**ASSESSMENT OF
ENVIRONMENTAL ISSUES
FOR THE PROPOSED
KYOTO ENERGY PARK –
AVIATION**

Client	Pamada Pty Ltd
Contact	Mark Dixon
Document No	2621/PR/004
Issue No	C
Status	Final
Classification	Client's Discretion
Date	28 August 2008

Response to Aviation Issues
from the Department of Defence
(12 March 2008)

PROPOSED KYOTO ENERGY PARK - SCONE NSW

Figure 2 Map of the Obstacle Limitation Surface (OLS) for the Scone aerodrome nearby to the proposed Kyoto Energy Park.

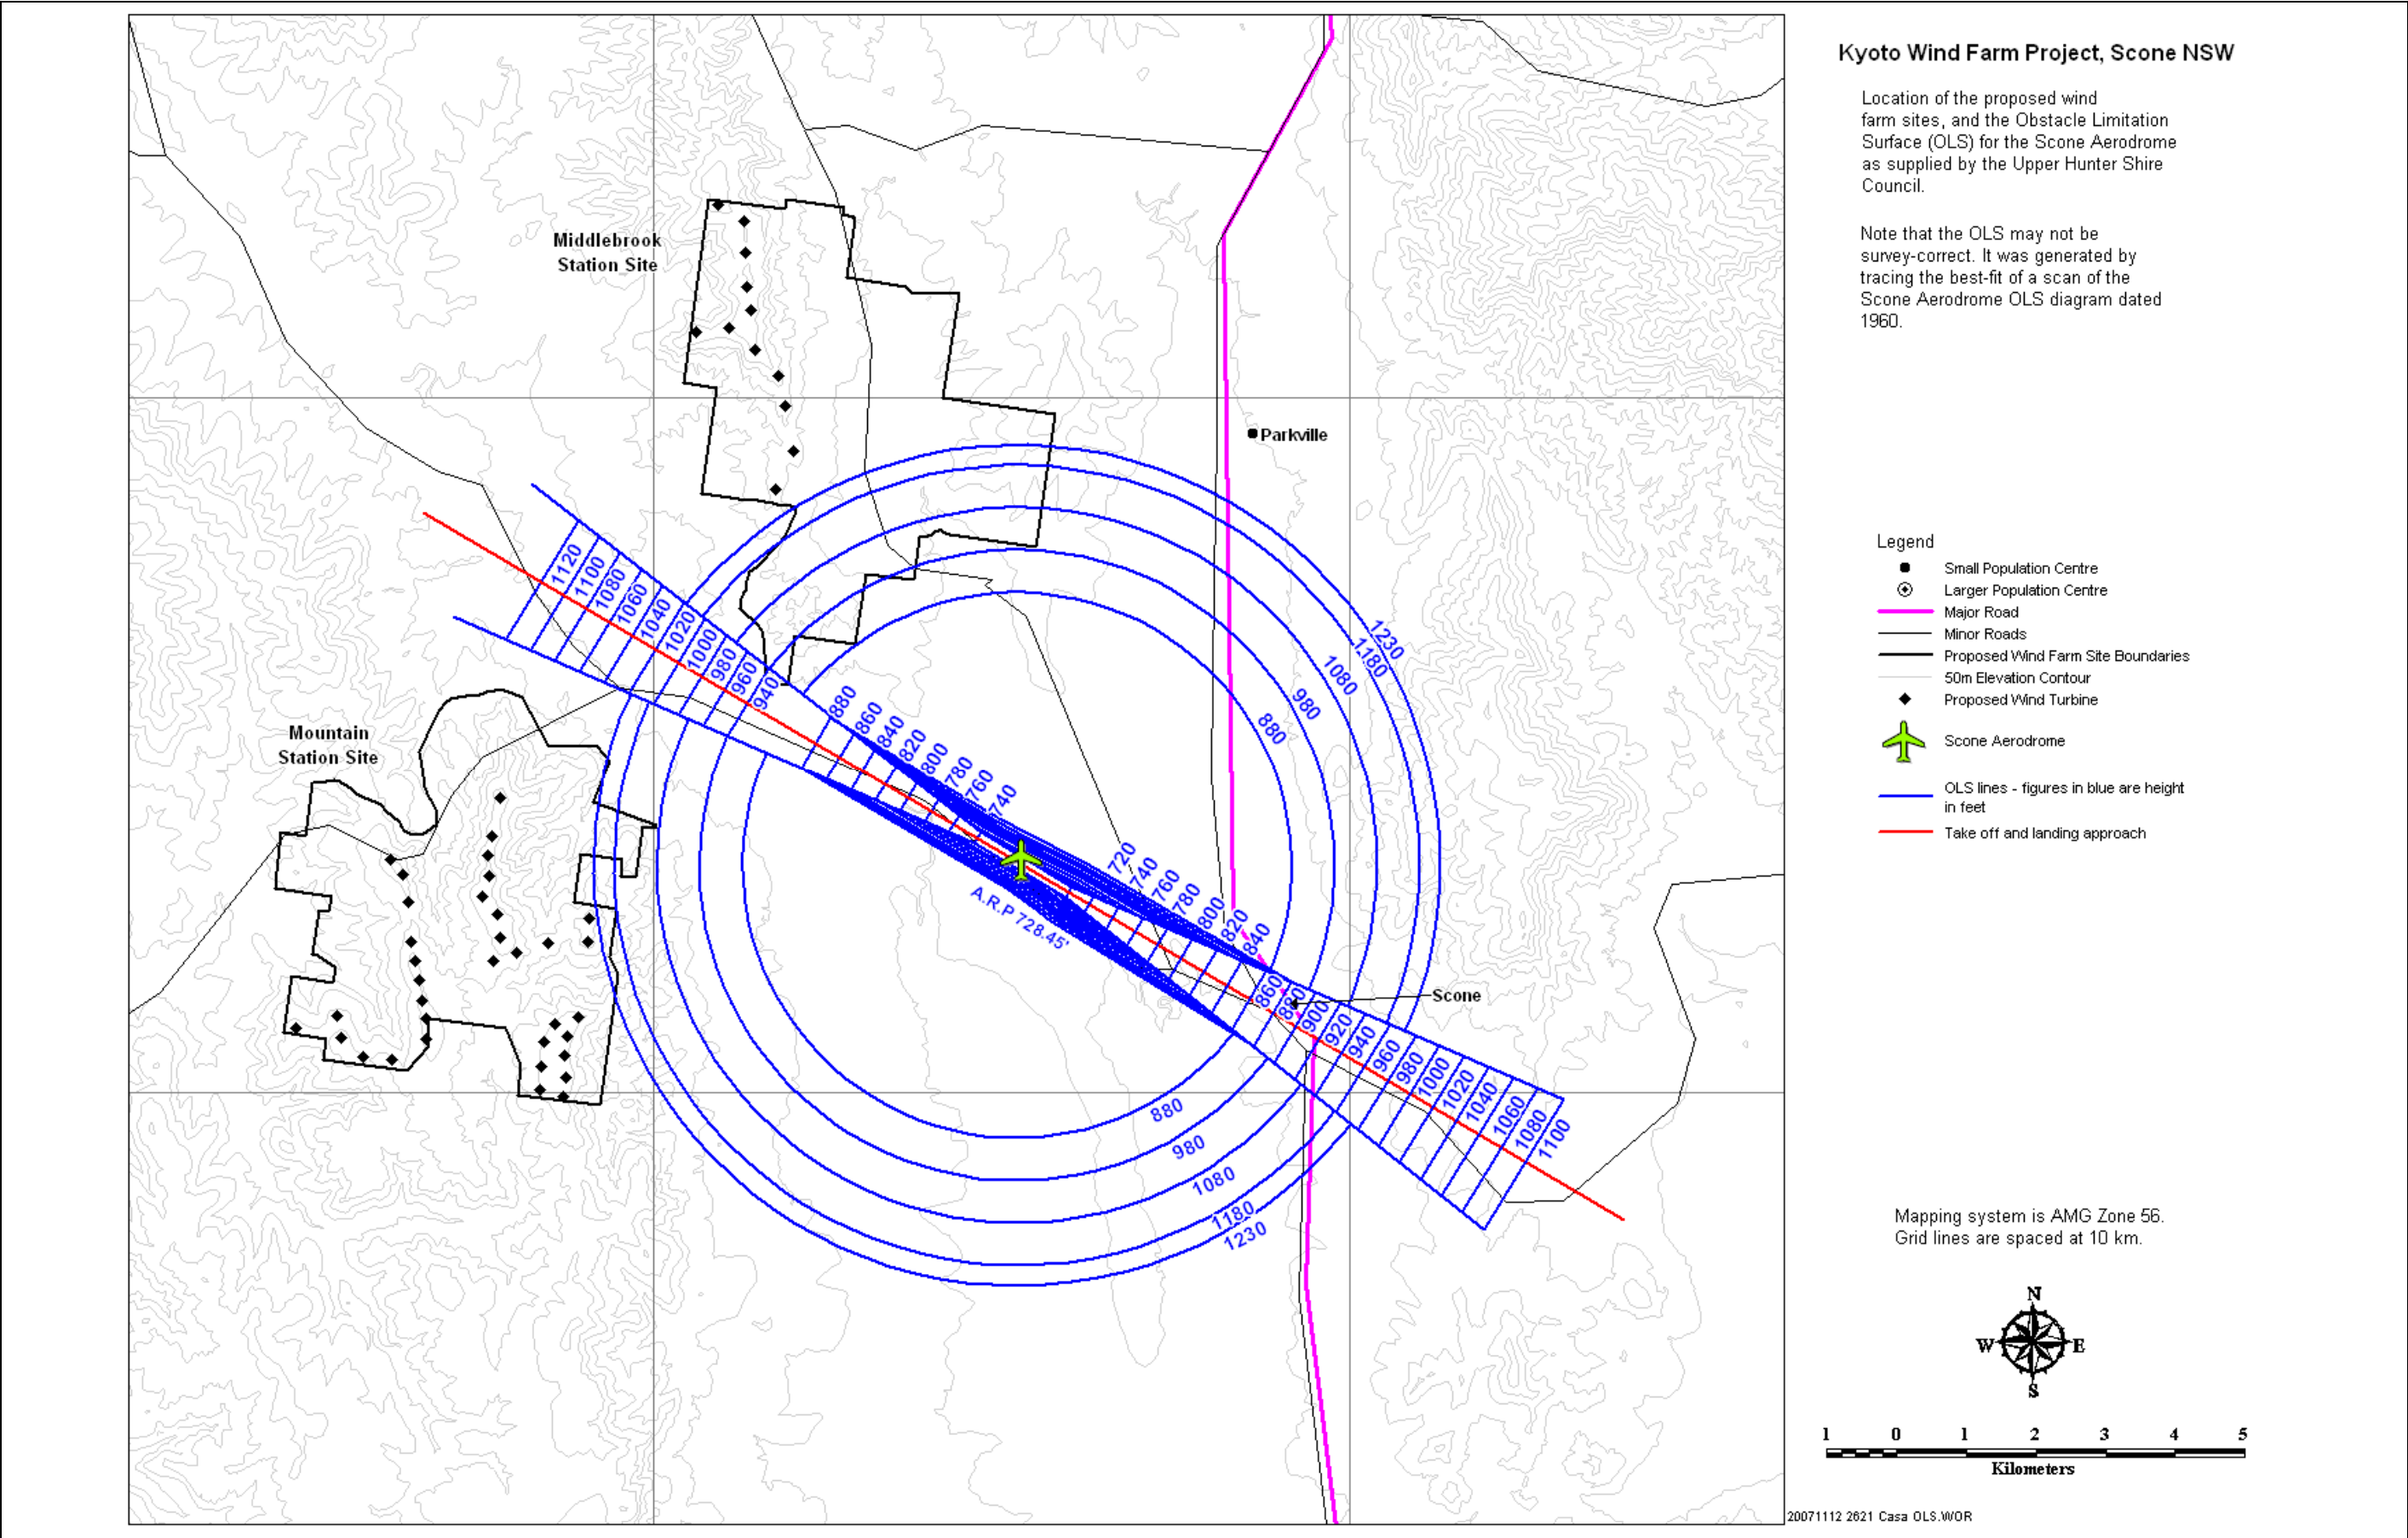
A map of the Obstacle Limitation Surface (OLS) was obtained from the operator of the Scone aerodrome, the Upper Hunter Shire Council. The OLS is shown in Figure 2. It can be seen that the turbines within the proposed Kyoto Energy Park project are outside of the OLS.

CASA replied to GH on the 31st October 2007 [3] and indicated that despite the proposed turbines being outside of the OLS, obstacle lighting would be required under the CASA Advisory Circular AC 139-18(0) titled 'Obstacle Marking and Lighting of Wind Farms'.

Figure 3 29 RNAV missed approach to the run way procedure.

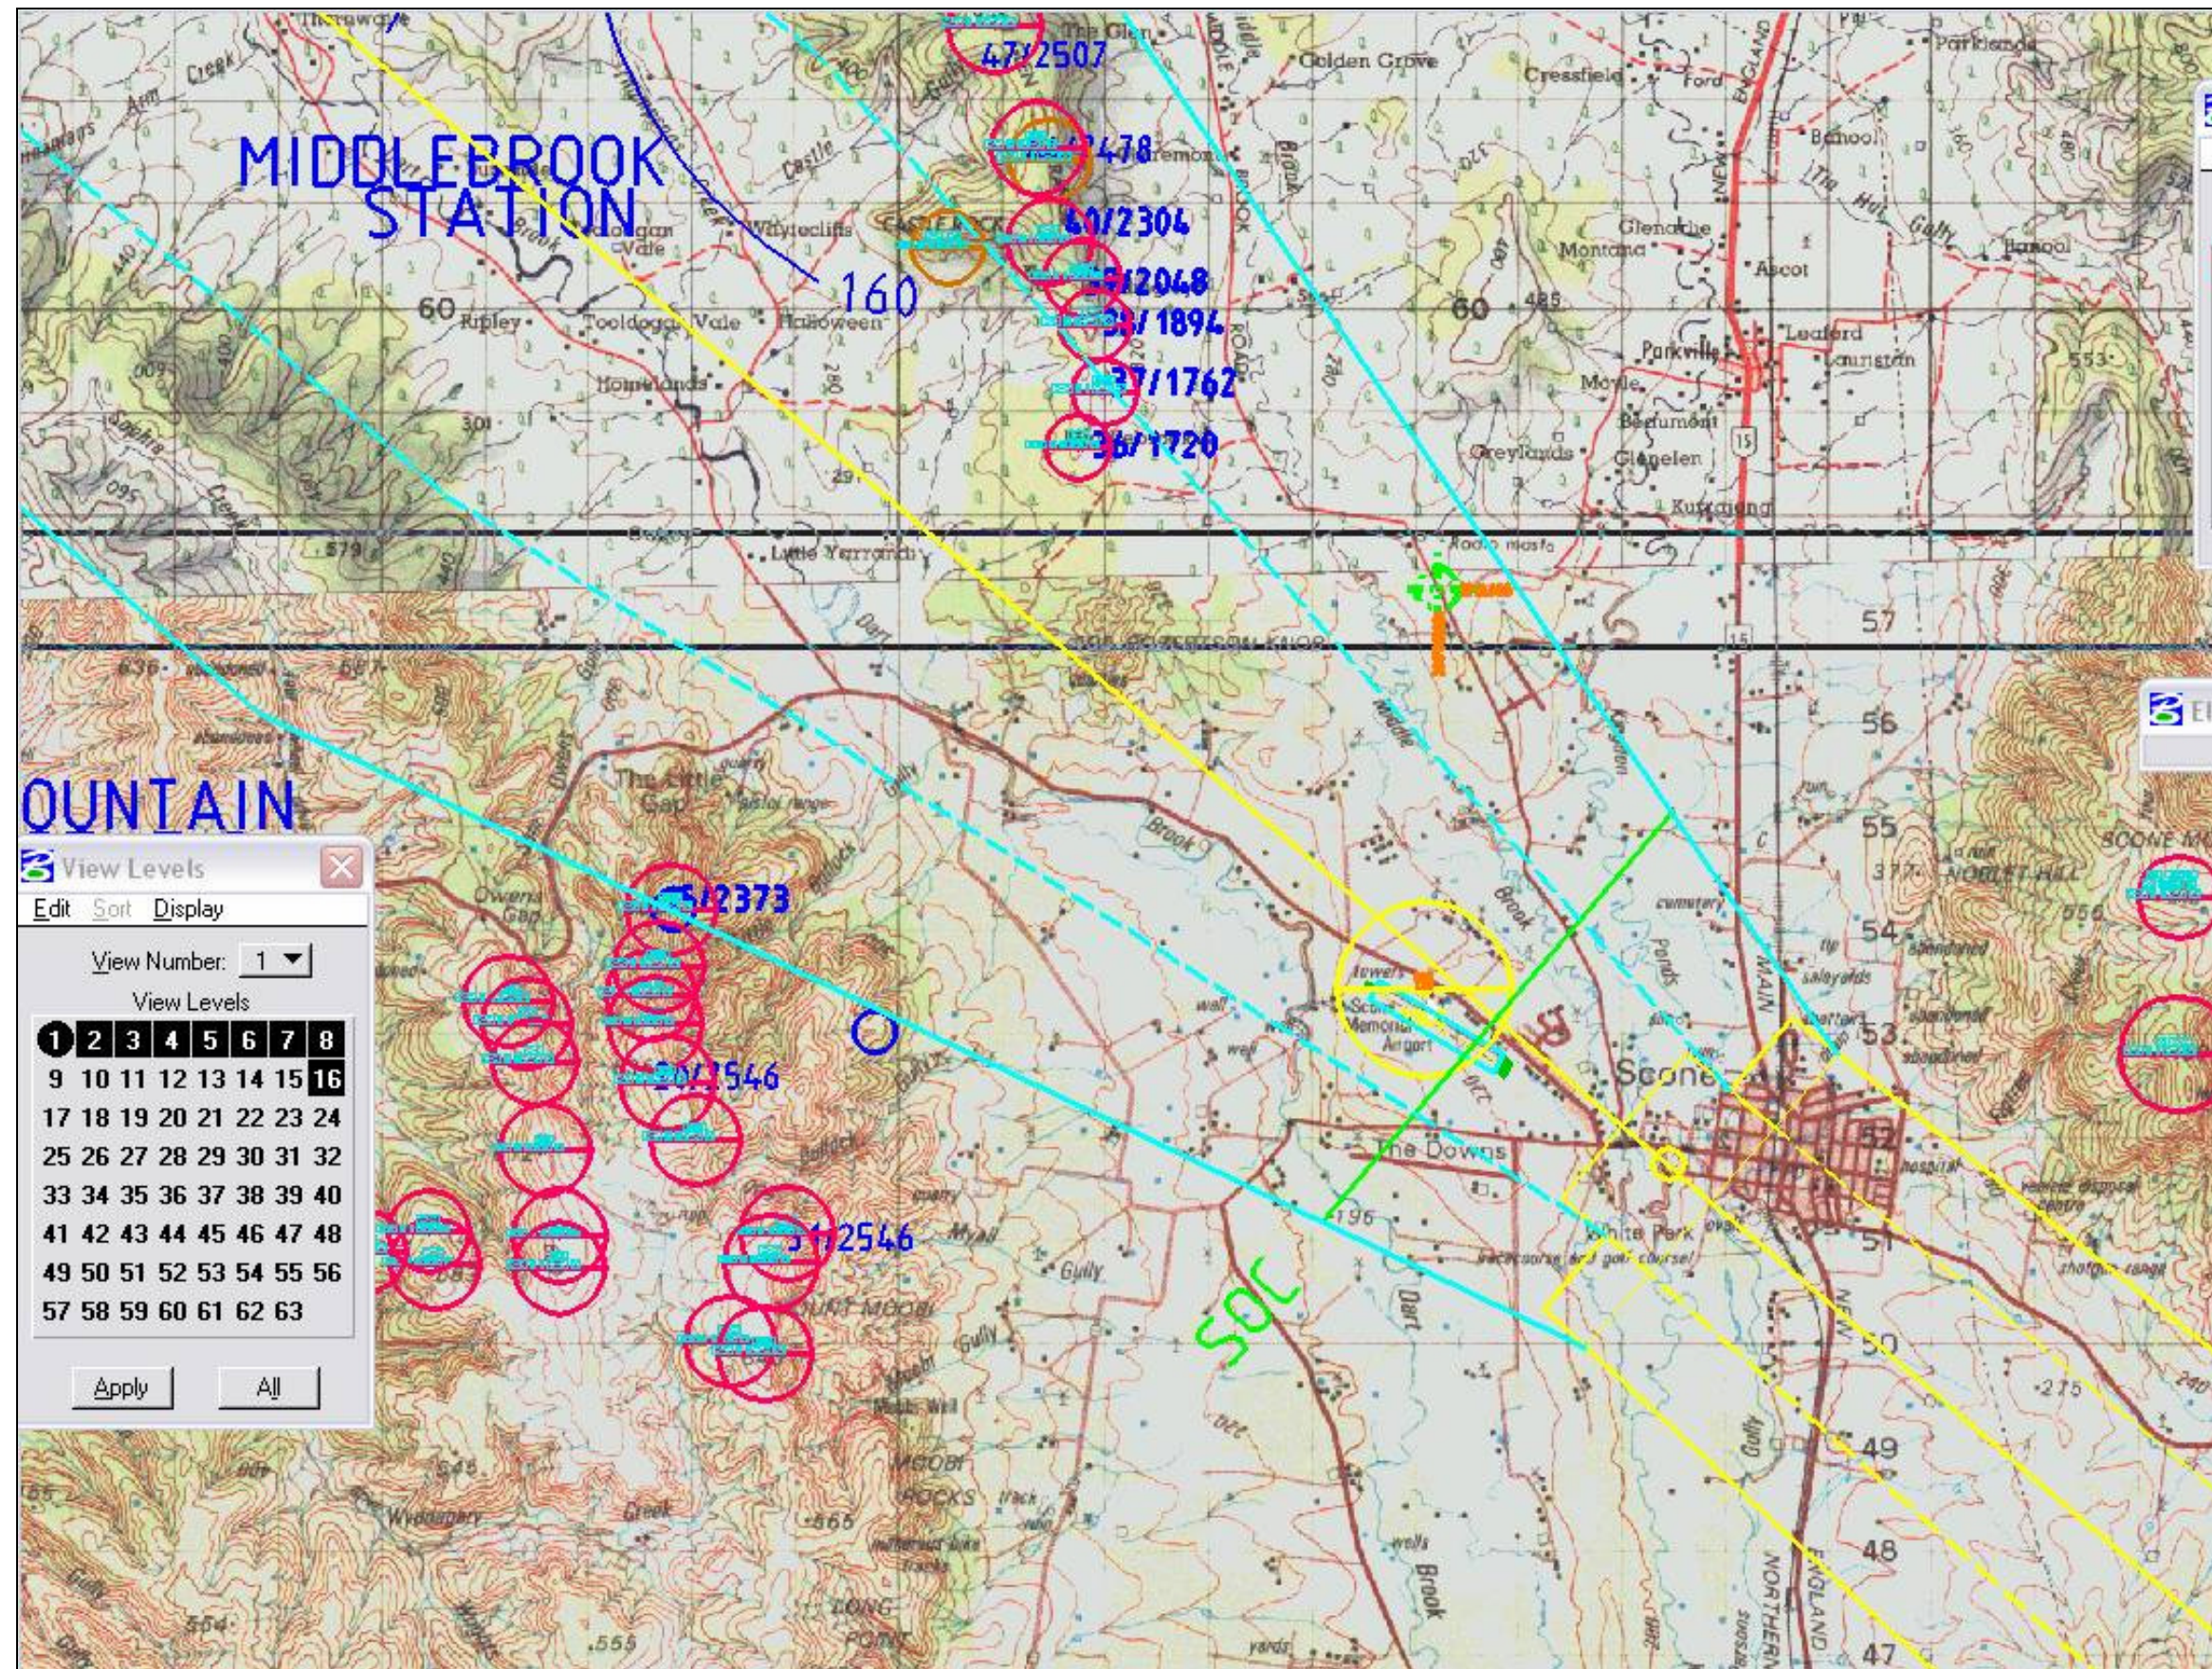
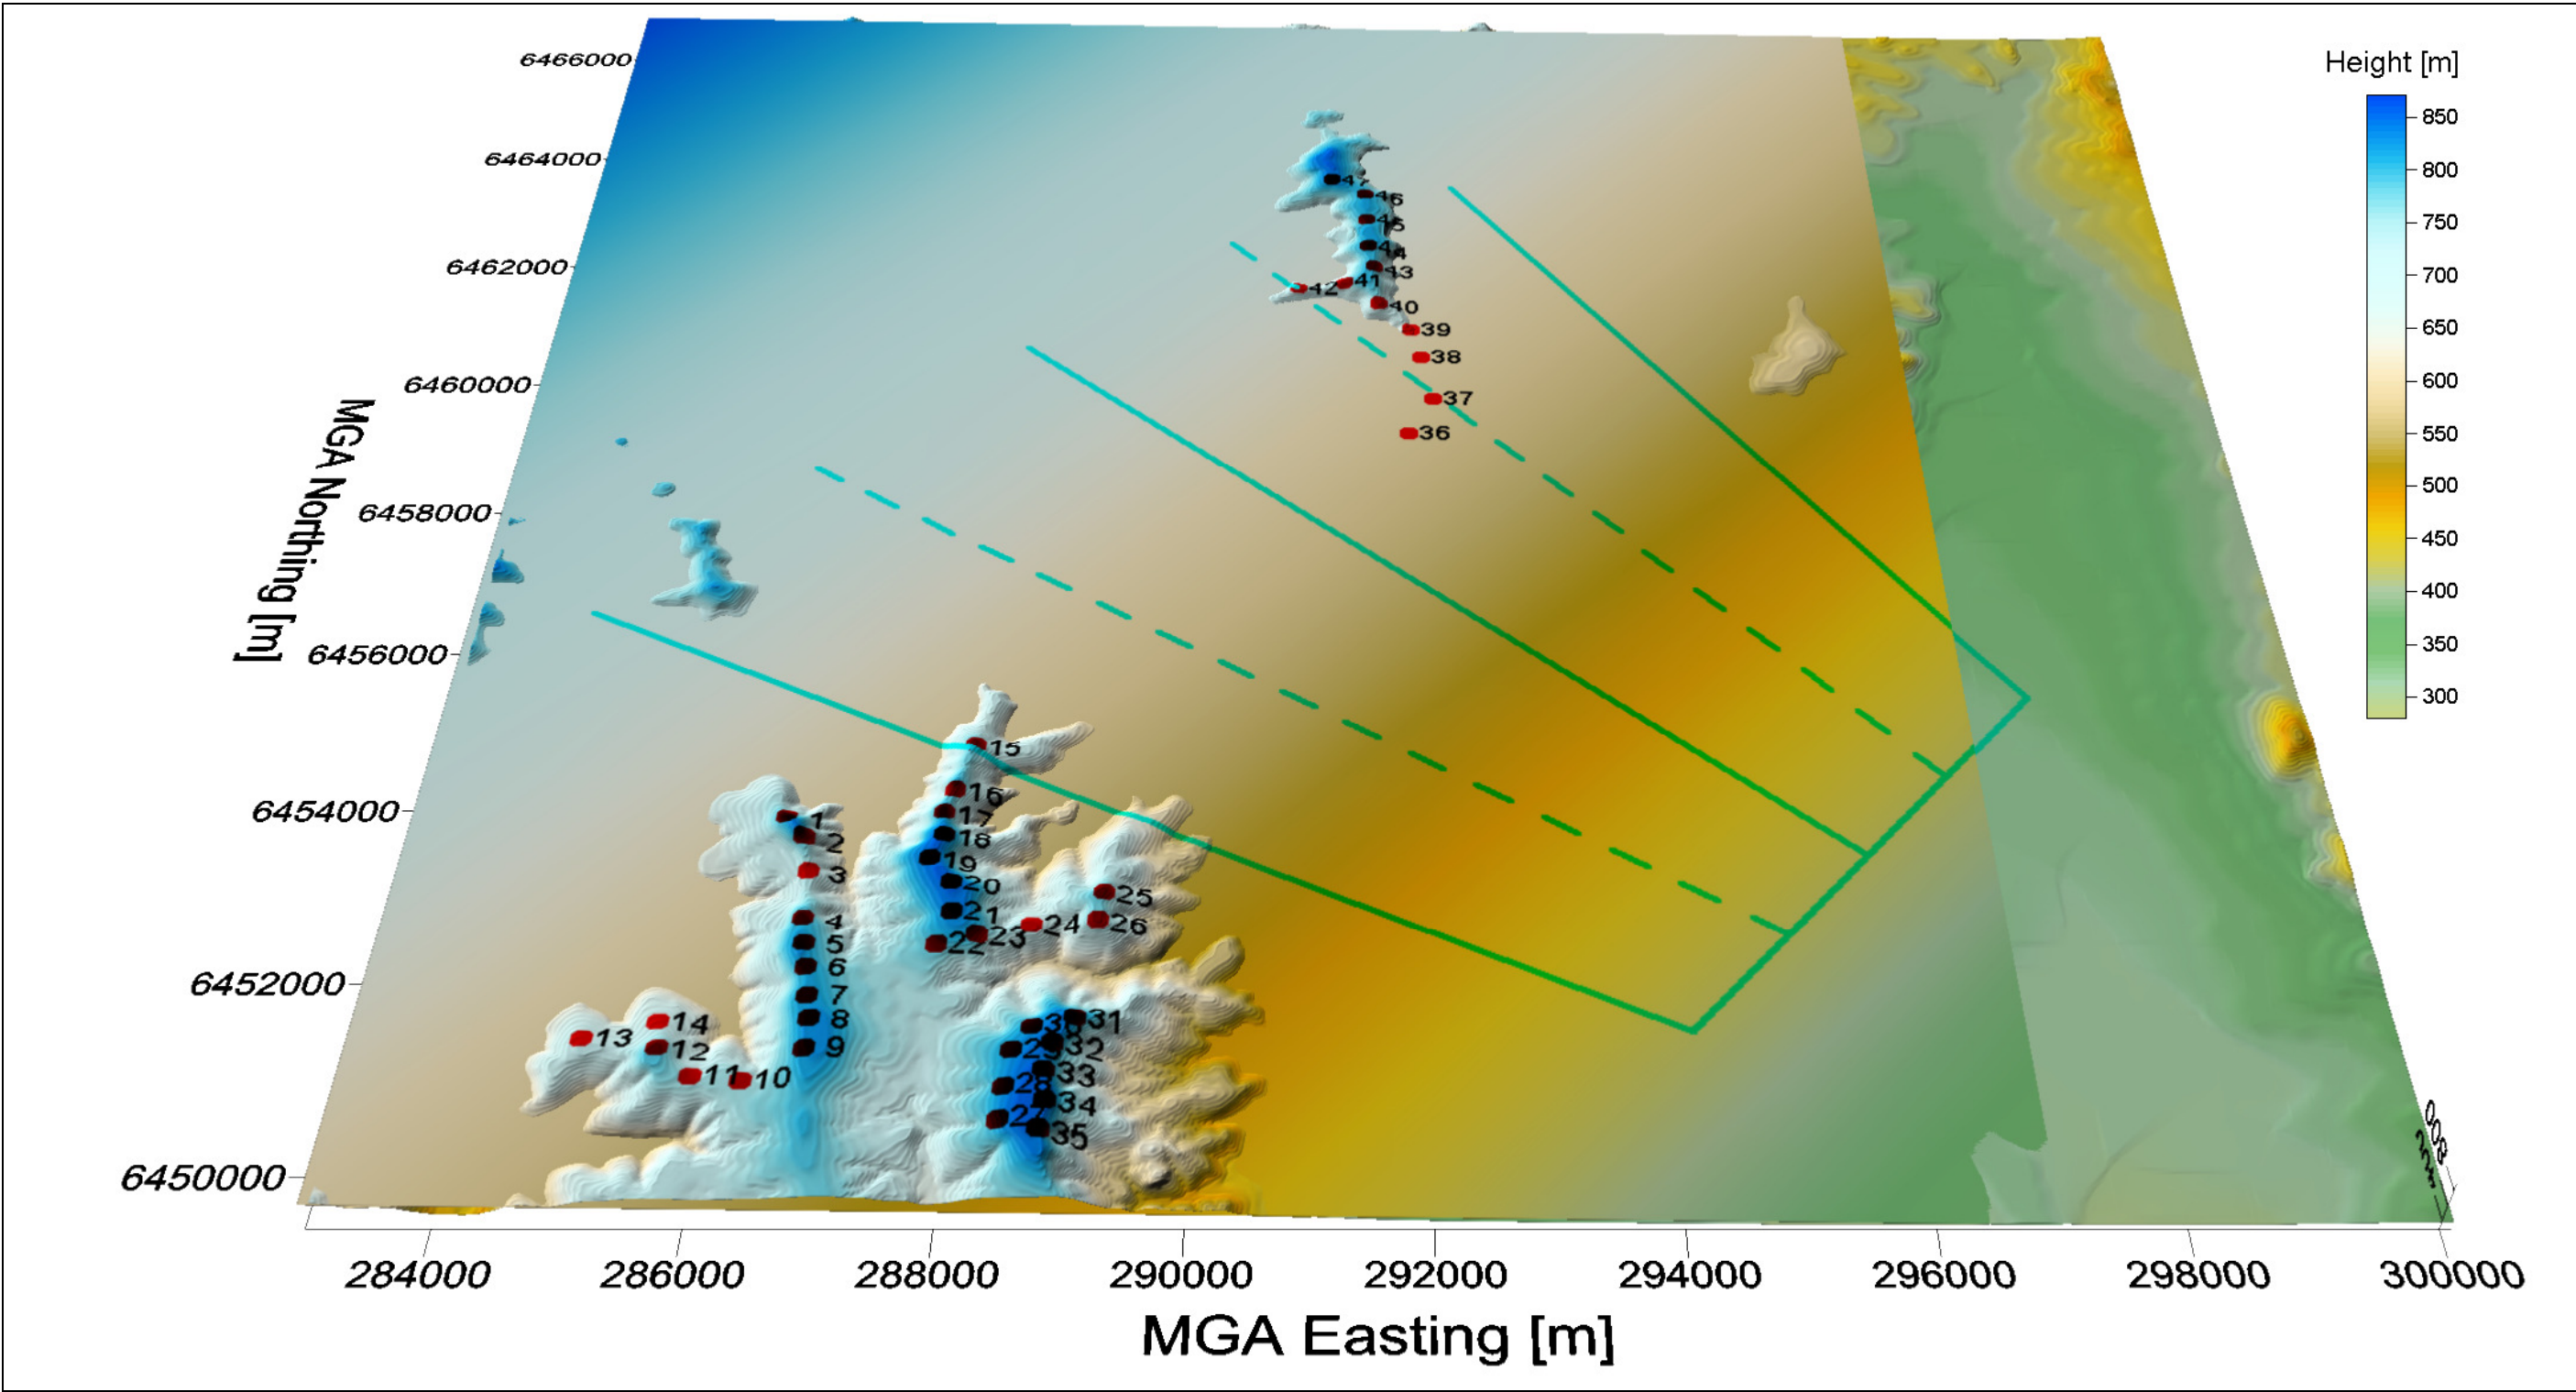
Airservices Australia indicated that in the old layout, turbines 15 and all those north of turbine 39 inclusive (39,40, 41, 42, 43, 44, 45, 46 and 47) infringe the 29RNAV procedure [7]. GH concurred with this finding.

The revised layout for the proposed Kyoto Energy Park project has incorporated an 80m move south to turbine 15 which sees it no longer infringing the 29RNAV procedure. With this revised layout, turbines 36, 37, 38, 39, 40, 41 and 42 are left infringing the 29RNAV procedure.
